MICROCHIP dsPIC33EPXXXGM3XX/6XX/7XX FAMILY

dsPIC33EPXXXGM3XX/6XX/7XX Family Silicon Errata and Data Sheet Clarification

The dsPIC33EPXXXGM3XX/6XX/7XX family devices that you have received conform functionally to the current Device Data Sheet (DS70000689D), except for the anomalies described in this document.

FIGURE 1: TIMING DIAGRAMS FOR CENTER-ALIGNED AND EDGE-ALIGNED MODES

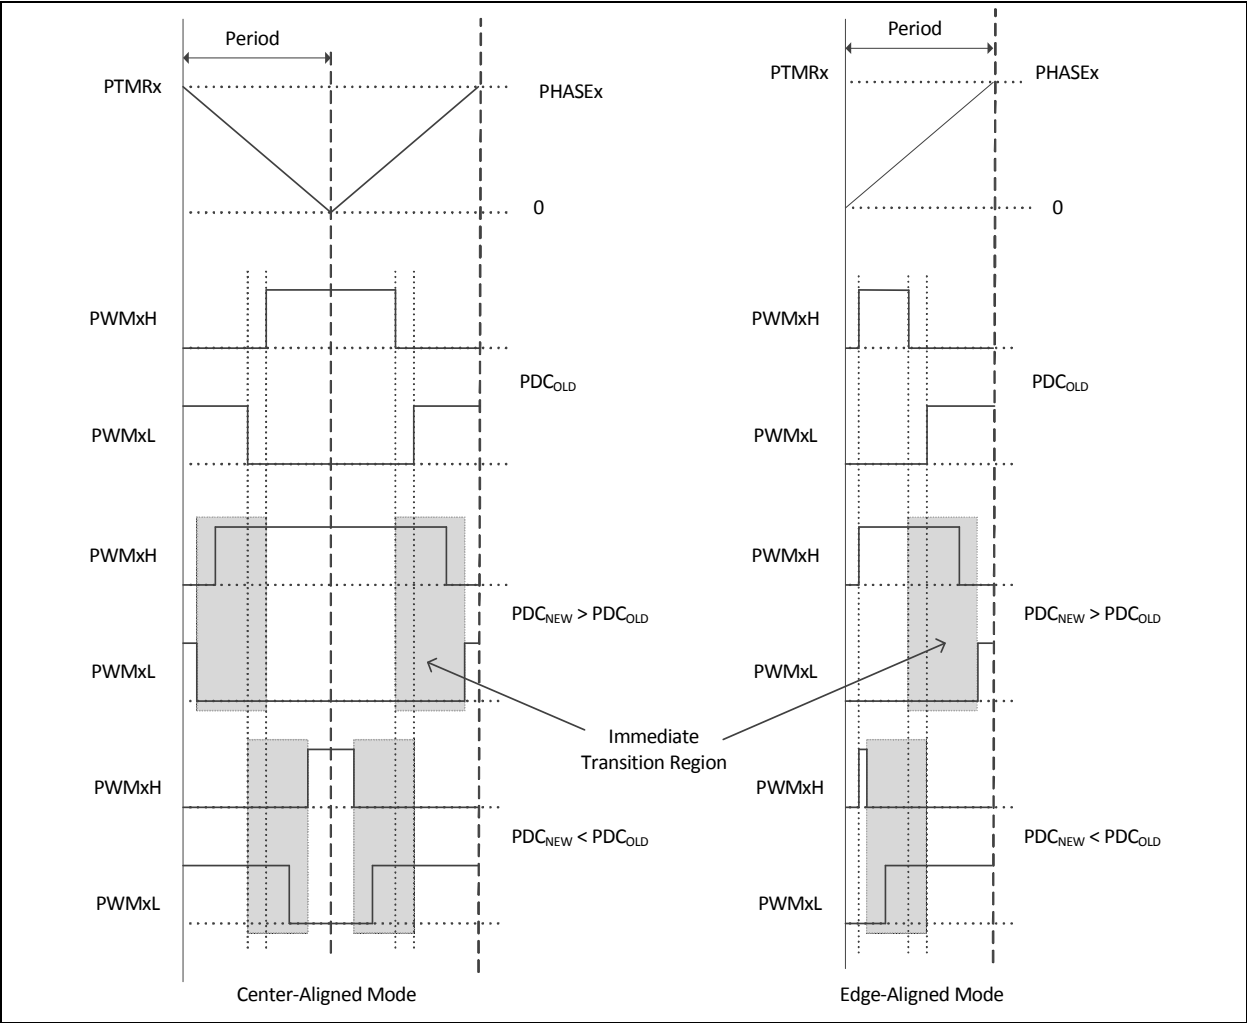
The PWM generator may not assert dead time on the edges of transitions. This has been observed when all of the following conditions are present:

- The PWM generator is configured to operate in Complementary mode with Independent Time Base (ITB) or master time base;
- Immediate update is enabled; and
- The value in the PDC register is updated in such a manner that the PWMxH and PWMxL outputs make an immediate transition.

The current duty cycle, PDC_{OLD}, newly calculated duty cycle, PDC_{NEW}, and the point at which a write to the Duty Cycle register occurs within the PWM

time base, will determine if the PWMxH and PWMxL outputs make an immediate transition. PWMxH and PWMxL outputs make an immediate transition if the Duty Cycle register is written with a new value, PDC_{NEW}, at a point of time when the PWM time base is counting a value that is in between PDC_{NEW} and PDC_{OLD}. Additionally, writing to the Duty Cycle register, close to the instant of time where dead time is being applied, may result in a reduced dead time which is effective on the PWMxH and PWMxL transition edges.

In Figure 1, if the duty cycle write occurred in the shaded box, then PWMxH and PWMxL will make an immediate transition without dead time.

In most applications, the duty cycle update timing can be controlled using the TRIGx trigger, or Special Event Trigger, such that the above mentioned conditions are avoided altogether.

FIGURE 2: PWM GENERATOR TIMING DIAGRAM

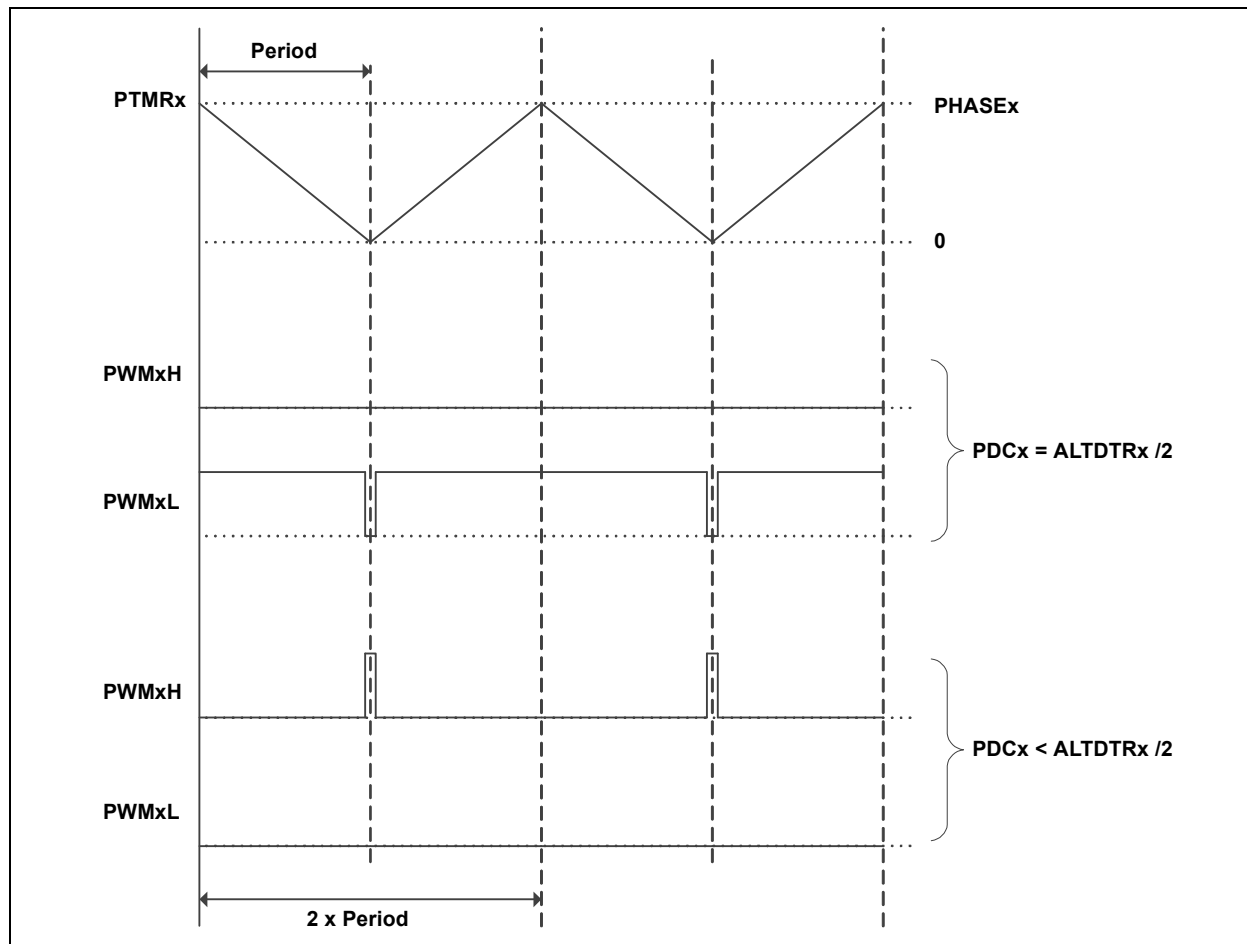
In Center-Aligned Complementary mode with Independent Time Base, if the value in the PDCx register is less than one-half the value in the ALTDTRx register, the PWM generator will force the PWMxL to low, and on the PWMxH, generates pulses of a width less than twice the dead time, as shown in Figure 2.

Include a software routine to ensure that the duty cycle value written to the PDCx register is at least one-half of the value in ALTDTRx. Example 1 shows one method, with PDCtemp representing the variable which has the value to be written to the PDCx register. Alternatively, for duty cycle values less than half the desired dead-time value, zero out the ALTDTRx register or dynamically reduce the value in the ALTDTRx register, such that ALTDTRx is always equal to $2 * PDCx$, as shown in Example 2.

FIGURE 3:

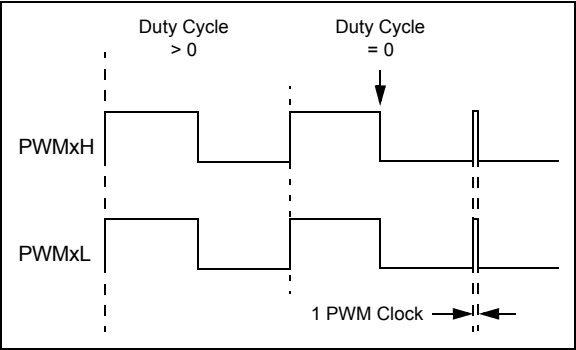
In certain output modes, the PWMx module produces a pulse glitch of one PWM clock in width (Figure 3). This has been observed only when all of the following are true:

- Either Redundant or Push-Pull Output mode is selected ($\text{IOCONx}\langle 11:10 \rangle = 10$ or 01);
- Immediate Update is disabled ($\text{PWMCONx}\langle 0 \rangle = 0$); and
- The value of the current Duty Cycle register (either the PDCx or MDC register, as determined by $\text{PWMCONx}\langle 8 \rangle$) is updated to zero from any non-zero value.

The pulse glitch has been observed to occur at the beginning of the following PWM boundary period.

If the application requires a duty cycle of zero, two possible work arounds are available.

1. Use the PWM overrides to force the output to a low state, instead of writing a '0' to the Duty Cycle register. When using this method, the PWM override must be disabled when the duty cycle is a non-zero value. If output override synchronization is configured to occur on CPU clock boundaries ($\text{IOCONx}\langle 0 \rangle = 0$), enabling and disabling the override must be timed to occur as closely as possible to the PWM period boundary.
2. Configure the module for Immediate Update ($\text{PWMCONx}\langle 0 \rangle = 1$) *before* enabling the module. In this mode, writes to the Duty Cycle register have an immediate effect on the output. As with the previous work around, writes to the Duty Cycle register must be timed to occur as close to the PWM period boundary as possible in order to avoid distortion of the output.

FIGURE 4:

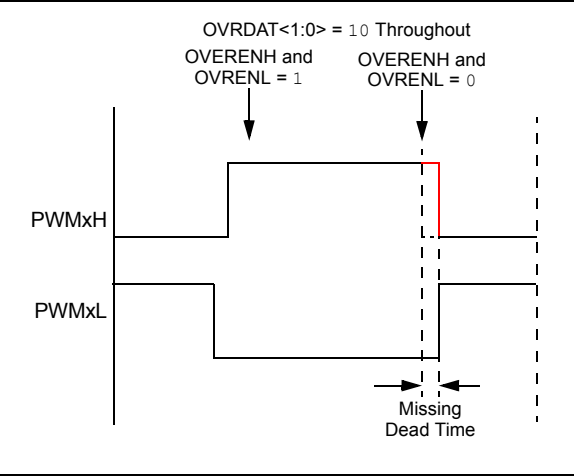
In Complementary Output mode, the expected dead time between transitions of the PWMxH and PWMxL outputs may not be asserted when the following occurs:

- Output override synchronization is configured to occur on the CPU clock boundary ($\text{IOCONx}\langle 0 \rangle = 0$);
- Both PWMxH and PWMxL overrides are enabled prior to the event (OVRENH and OVRENH are both '1'), and
- Both overrides are disabled (OVRENH and OVRENH are both '0') at the instant the dead time should be asserted (Figure 4).

This has been observed in both Center-Aligned and Edge-Aligned modes.

FIGURE 5:

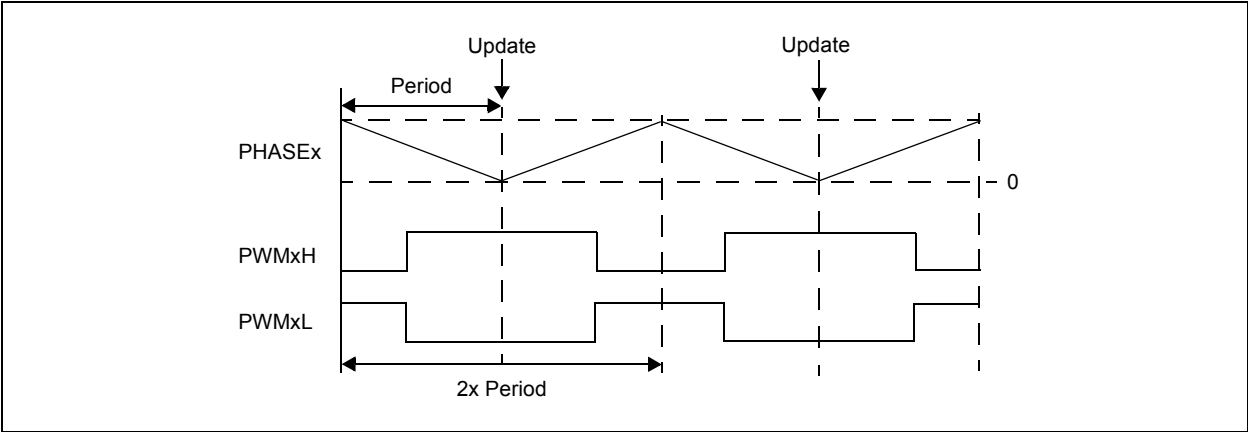
In Center-Aligned Complementary mode with Independent Time Base, updates to the PHASEx register take effect in the middle of a Center-Aligned PWM cycle, as shown in

Figure 5. This occurs only when the Immediate Update feature is disabled (IUE = 0). If Immediate Update is enabled (IUE = 1), the PHASEx register updates will take effect immediately.

64-Lead Plastic Quad Flat, No Lead Package (MR) – 9x9x0.9 mm Body with 5.40 x 5.40 Exposed Pad [QFN]

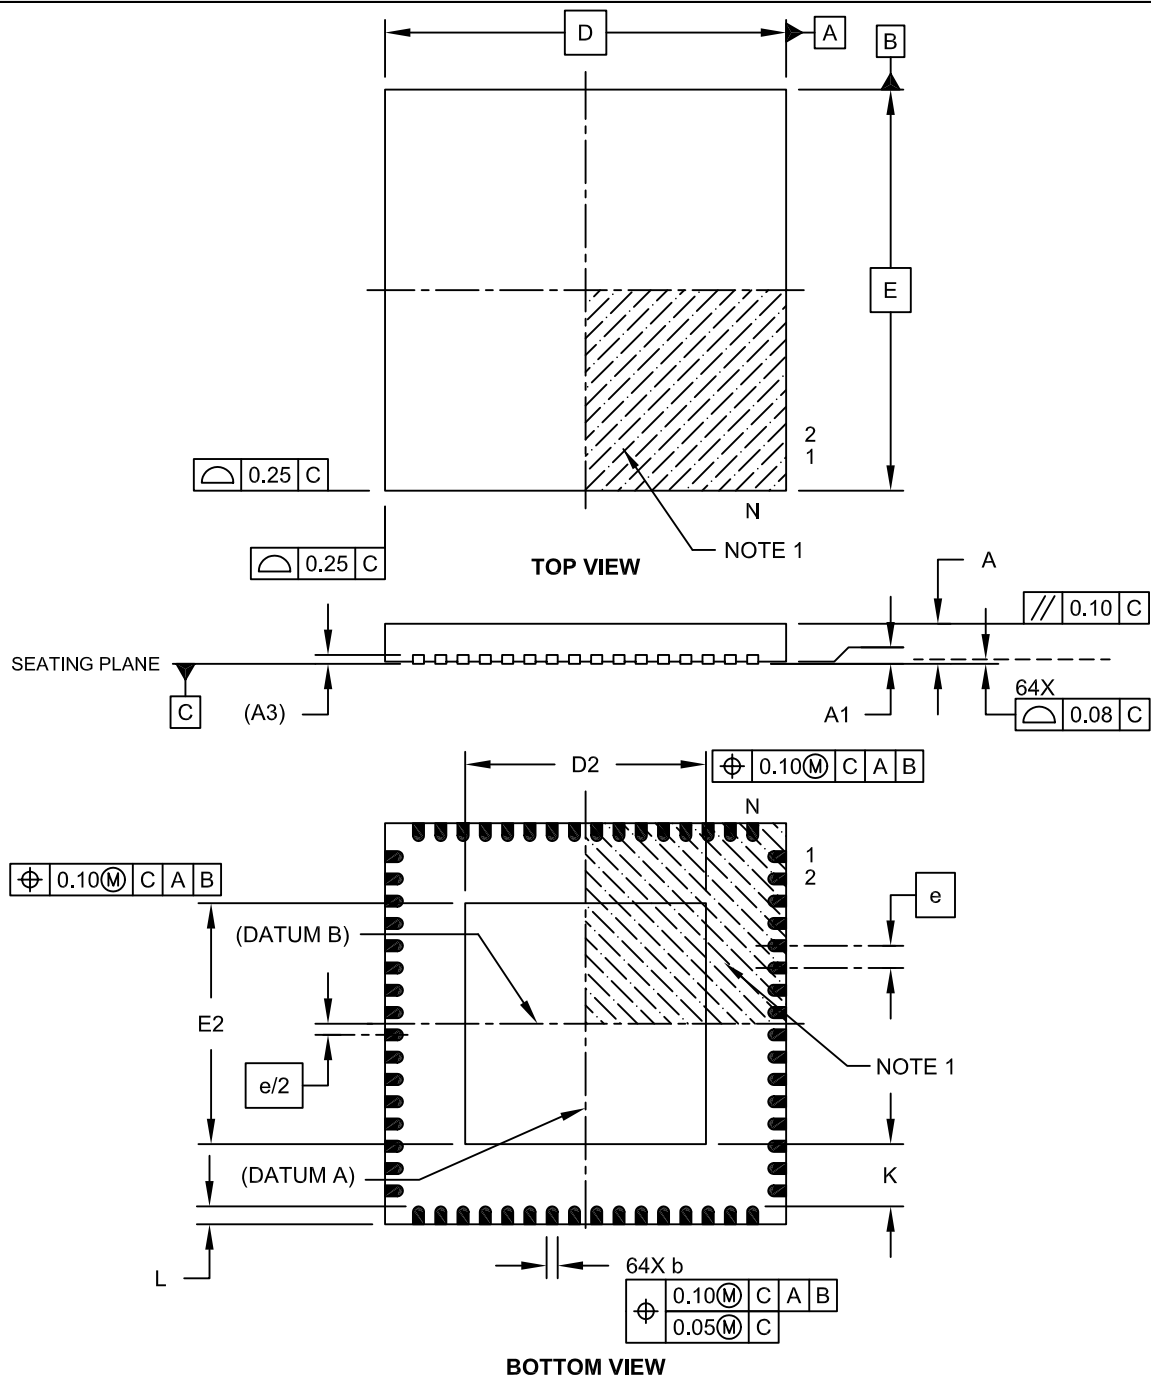
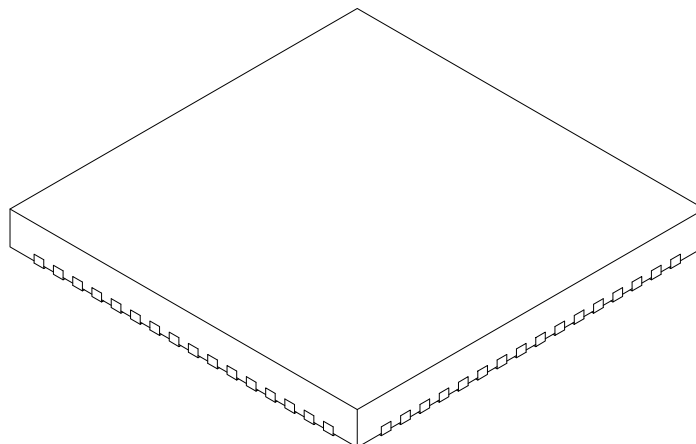
In the “*dsPIC33EPXXXGM3XX/6XX/7XX Family Data Sheet*”, **Section 35.2 “Package Details”**, dimensions for the 64-Lead Plastic Quad Flat, No Lead Package (MR) - 9x9x0.9 mm Body with 7.15 x 7.15 Exposed Pad [QFN] is mentioned. However, the dsPIC33EPXXXGM3XX/6XX/7XX family devices are not available in this package.

The dsPIC33EPXXXGM3XX/6XX/7XX family devices are available in the 64-Lead Plastic Quad Flat, No Lead Package (MR) – 9x9x0.9 mm Body with 5.40 x 5.40 Exposed Pad [QFN], and the package dimensions are shown on the following pages.
